## FIELD OBSERVATION REPORT

West Hardin Middle School, 202280 -CA8

Report No: 31

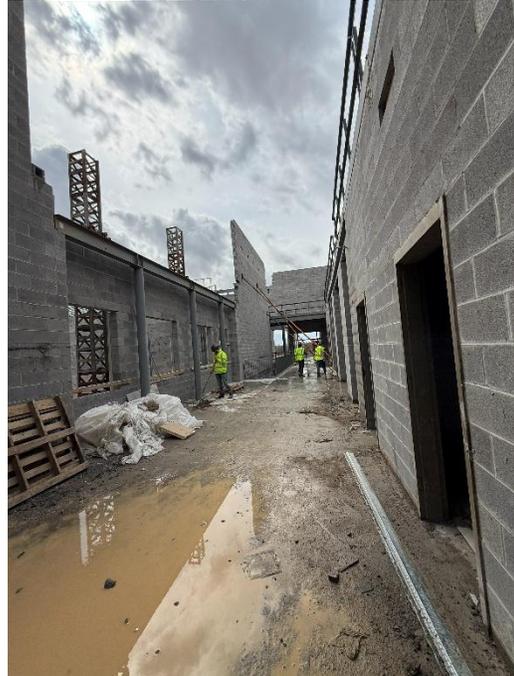
- k) Light gauge roof trusses were installed over the two southernmost wings of classrooms.
